UNITED STATES PATENT AND TRADEMARK OFFICE

10/588,936

Office Action Summary	Application No. 10/588,936	Applicant(s) TABATA ET AL.	
	Examiner LUCAS STELLING	Art Unit 1778

FIG.12

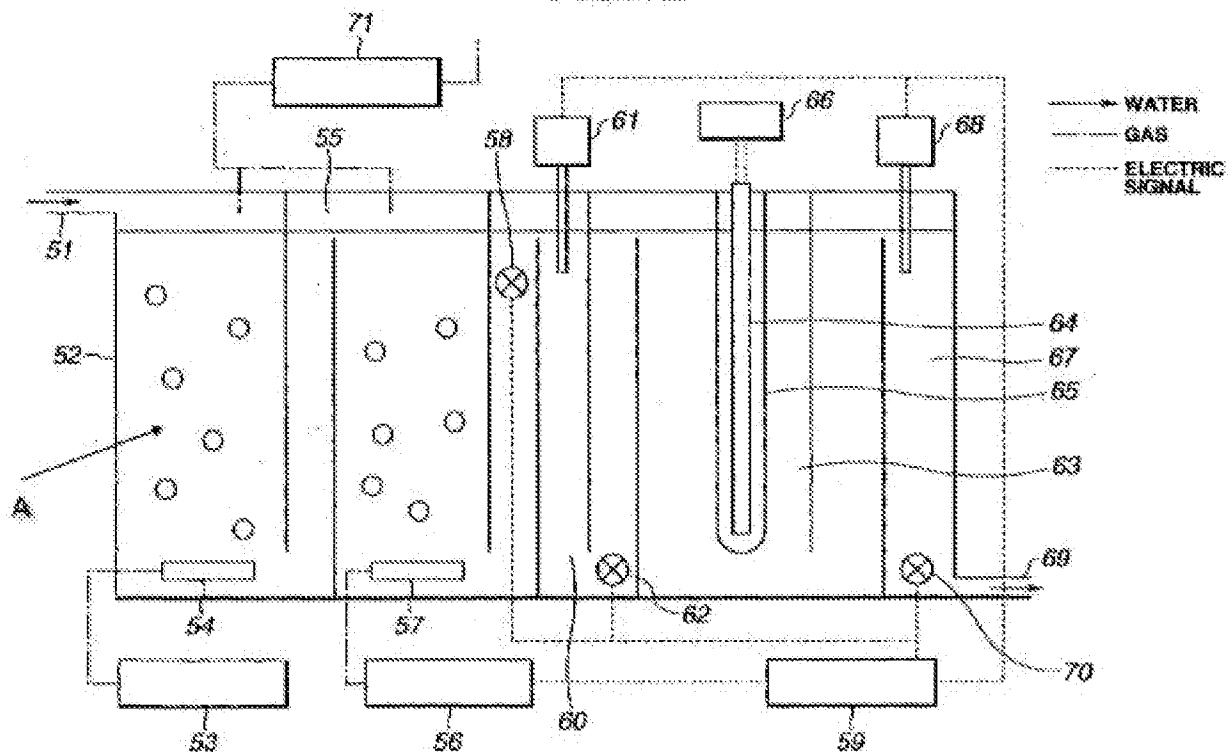
a wastewater treatment bath for treating wastewater (**See Noguchi Fig. 12, and edited Fig. 12 below, 'A' represents the treatment bath into which ozone is provided through 54 see also [0046]**);

an oxidizing reagent adding unit for adding an oxidizing reagent in the waste water treatment bath (**54 and see [0046]**);

an ultraviolet treatment unit (**63 is a photocatalytic reaction vessel, having an ultraviolet lamp 64**) for irradiating an ultraviolet ray comprising:

a reaction bath that receives the oxidized water fed from wastewater treatment bath (**63**); and

an ultraviolet lamp that irradiates the reaction bath (**64**); and

an acid treatment bath (**60**) having an acid adding unit (**61**) for adding acid, the acid treatment bath provided on a downstream side of the wastewater treatment bath and on an upstream side of the ultraviolet treatment unit(**See Noguchi Fig. 12 and see edited Fig. 12 below**).

Noguchi is different from claims 19 and 31, in that Noguchi does not teach a pump which feeds oxidized water from the wastewater treatment bath to the ultraviolet treatment unit reaction bath which receives the oxidized water from the pump, or that the a pair UV lamp is provided outside the reaction bath.
